Non-Material Amendment Application

Further to previous planning submission Ref: 2013/8192/P

Proton Beam Therapy - Phase 4
VIE - Non Material Amendment Application - Cross Section

1 VIE - 180144 Cross Section 1-50
1 : 50

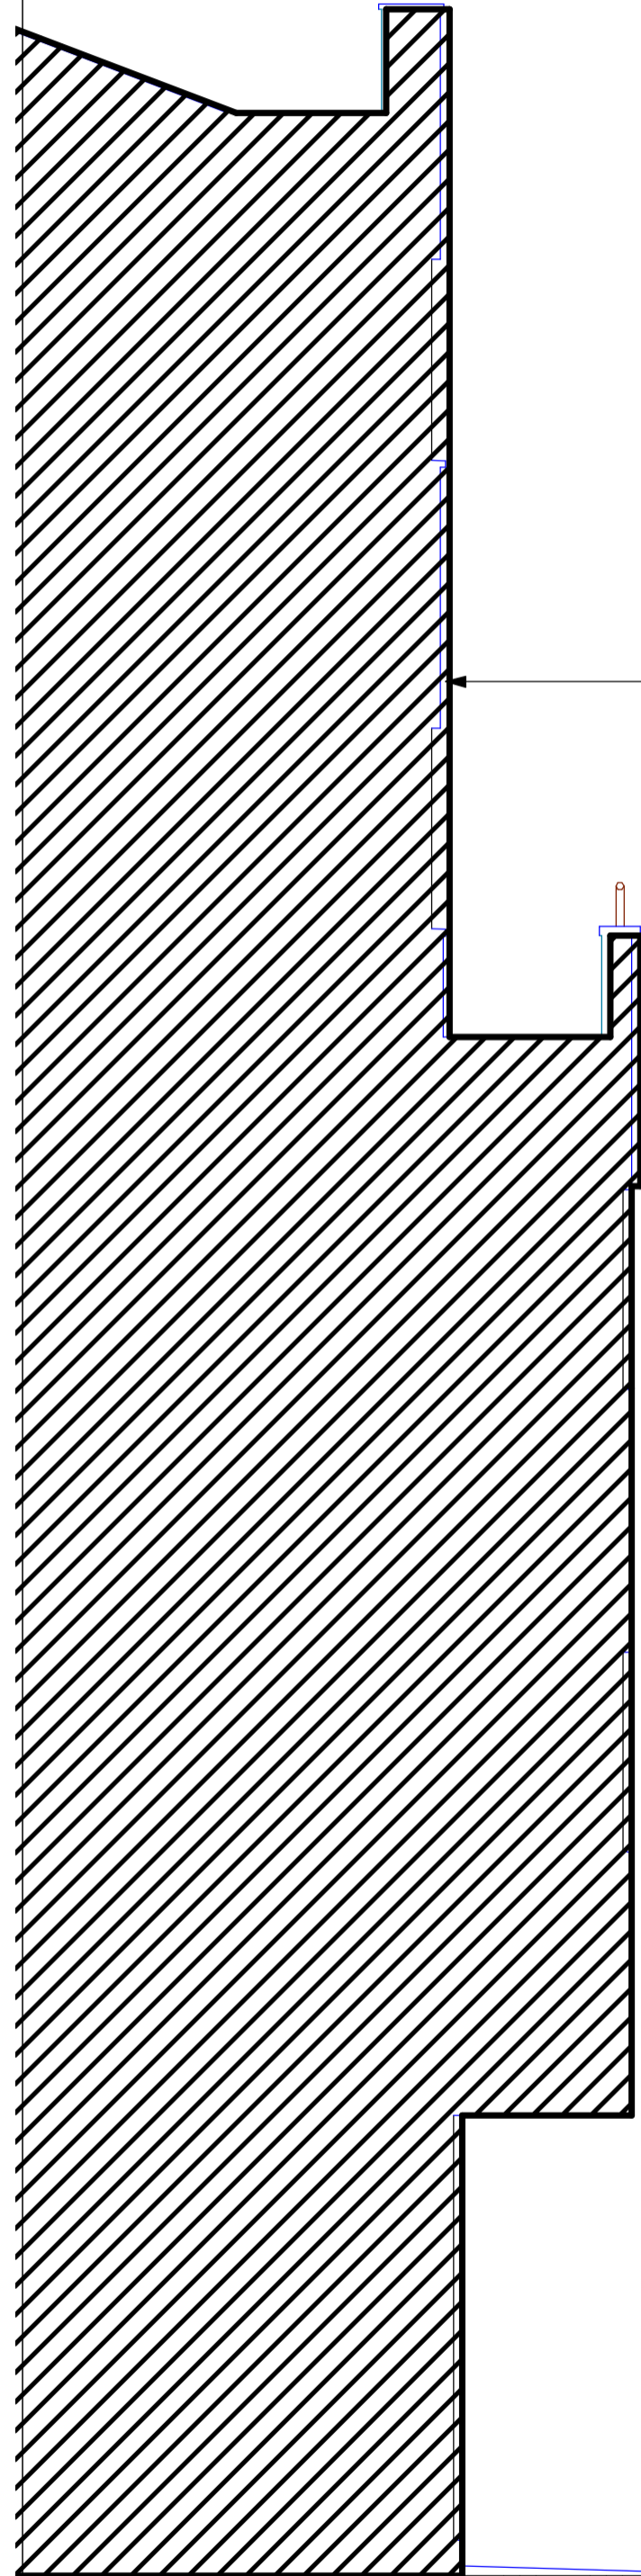
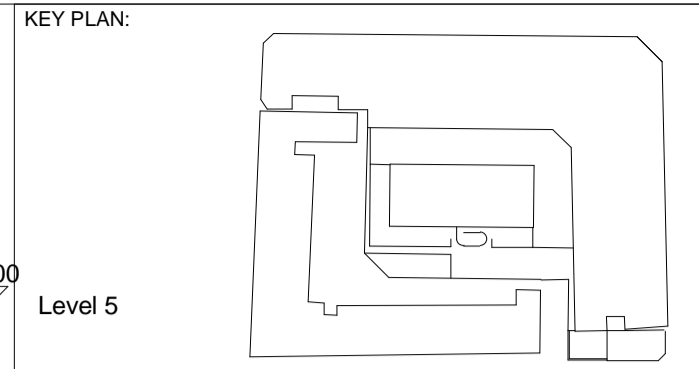
location of additional BOC Vent Pipe Stack not indicated in planning submission Ref: 2013/8192/P

Please find indicated in the drawings location of additional BOC Vent Pipe Stack not indicated in planning submission Ref: 2013/8192/P
